Access Compliance Report

Public Rights-of-Way

(Curb Ramps)

Intersection ID: 5213	Main Street: NORTH PARK_BV	Cross Street: REAMES_RD	Location: SE
ADA ID: 12B5B7C68787	Ramp Type: Combination1Diag	Initial Pass/Fail: Fail	Overall Compliance: No
Codes/Mitigation Info/Possible Solution		Field Measurements/Component Compliance	
Severity Score: 0

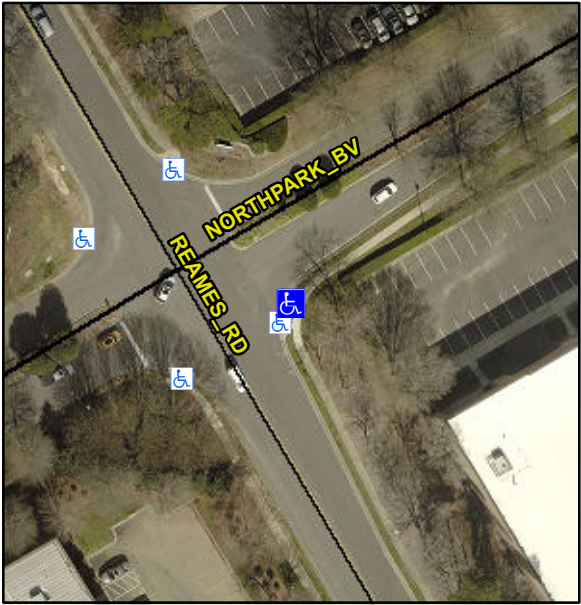
Possible Solutions:		Compliance	Description	Data	Compliance	Description	Data
	Remove & Replace Curb Ramp With Two New Directional Ramps or Equivalent.		N/A	Ramp Length LT (in)	56.0	N/A	Ramp Length RT (in)	56.0
			Yes	Ramp Width LT (in)	49.0	No	Ramp Width RT (in)	46.0
			Yes	Ramp Slope LT (%)	4.5	No	Ramp Slope RT (%)	8.9
			No	Ramp XSlope LT (%)	4.0	Yes	Ramp XSlope RT (%)	1.9
			N/A	Ramp Length (in)	54.0	No	Ramp Slope (%)	10.6
			Yes	Ramp Width (in)	55.5	No	Ramp XSlope (%)	7.2
			N/A	Flare Type LT	N/A	N/A	Flare Type RT	N/A
			N/A	Flare Slope LT (%)	N/A	N/A	Flare Slope RT (%)	N/A
			N/A	Flare Traversable LT?	N/A	N/A	Flare Traversable RT?	N/A
<p>Surveyor Notes:</p> <p>LT RP < 5%</p> <p>PROW/ADA:</p> <p>R304.5.1, R304.2.2, R304.5.3, R304.3.2</p>			N/A	Landing Length (in)	N/A	N/A	DWS Provided?	N/A
			N/A	Landing Width (in)	N/A	N/A	DWS Contrast?	N/A
			N/A	Landing Slope (%)	N/A	N/A	DWS Length (in)	N/A
			N/A	Landing X Slope (%)	N/A	N/A	DWS Full Width?	N/A
